# Access Audit Site Report

**McKinney Falls State Park**  
**5808 McKinney Falls Pkwy**  
**Austin, TX 78744**  
**Accessibility Evaluation**  
**Inspection Date: 11/11/2021**  
**Inspectors: Tanya Scheibe**

Prepared By  
**WT Group**

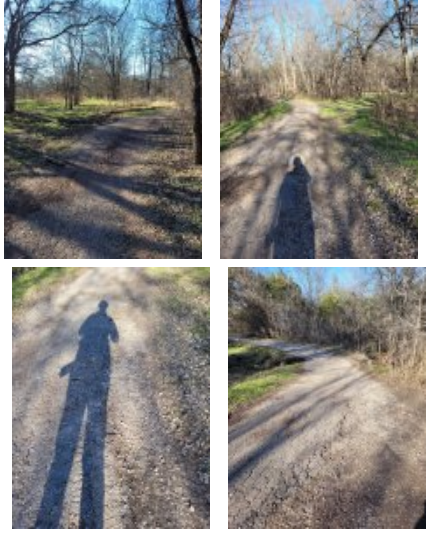
Finding Number	Area Description	Lat/Long	Finding	As Built	Recommendation	Citation	Photos	Figure
460	Trails: Trailhead	[30.1837271 , -97.727946 5]	There is no accessible route to the picnic tables At least one accessible route shall connect accessible buildings, accessible facilities, accessible elements, and accessible spaces that are on the same site.	No accessible route to picnic tables and grills - 0 of 60 picnic tables accessible	Create an accessible route with crushed stone or other outdoor material from parking or walkway to picnic tables	2015 ABAAS Section: F206.2.2  2012 TAS Section: 206.2.2  2010 ADAS Section: 206.2.2		
461	Trails: Trail Elements	[30.1752702 , -97.725656 6]	The element is not accessible because there is not adequate clear floor space for an approach. The clear floor or ground space shall be 30 inches minimum by 48 inches minimum.	At fork on onion creek trail - no CFS, left of fork bench same issue	Create AR with crushed and compacted stone or similar outdoor material from trail to the element	2015 ABAAS Section: 305.3  2012 TAS Section: 305.3  2010 ADAS Section: 305.3

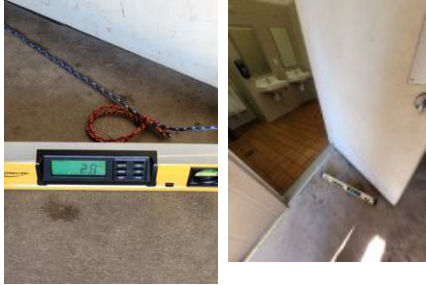
Finding Number	Area Description	Lat/Long	Finding	As Built	Recommendation	Citation	Photos	Figure
469	Trails: Trail Surface	[30.1840807, -97.7254674], [30.1843151, -97.7256961]	Not more than 30 percent of the total length of a trail shall have a running slope steeper than 1:12 (8.33%). The running slope of any segment of a trail shall not be steeper than 1:8 (12%). Where the running slope of a segment of a trail is steeper than 1:20 (5%), the maximum length of the segment shall be in accordance with Table 1017.7.1, and a resting interval complying with 1017.8 shall be provided at the top and bottom of each segment.	Slope to upper falls by Smith building, est. 50 feet - middle 13%, 15.5% at top, 16.1% at bottom.	Correct trail running slope to not exceed 8.33% slope for 200' max, 10% for 30' max or 12.5% for 10' with resting spaces on the trail as a smart practice	2015 ABAAS Section: 1017.7.1

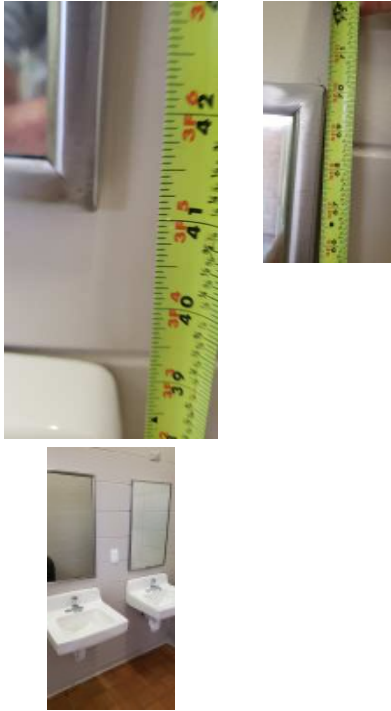
471	Amphitheater Restrooms: Amphitheater Women's Restroom	[30.181146, -97.7288343]	The restroom sign does not comply with one or more applicable requirements for the location, height, and properties of the sign.	Sign lacks Braille and raised characters, mounted above door	Replace sign with one of contrasting colors that includes Braille, raised characters, and the symbol of accessibility and mount on the wall, latch side of the door, 48" to the baseline of the lowest character and 60" to the baseline of the highest character	2015 ABAAS Section: F216.2, 703.1, 703.2, 703.5, 703.6  2012 TAS Section: 216.2, 703.1, 703.2, 703.5, 703.6  2010 ADAS Section: 216.2, 703.1, 703.2, 703.5, 703.6		
472	Amphitheater Restrooms: Amphitheater Women's Restroom	[30.1811642 , -97.7288262]	The mirror is mounted too high. Mirrors must have the bottom edge of the reflecting surface a maximum of 40 inches above the floor if above a sink or counter. Mirrors not located above lavatories or countertops shall be installed with the bottom edge of the reflecting surface 35 inches maximum above the finish floor or ground.	Mirror mounted 40.25" AFF	Lower mirror so reflective surface is max 40" AFF	2015 ABAAS Section: 603.3  2012 TAS Section: 603.3  2010 ADAS Section: 603.3
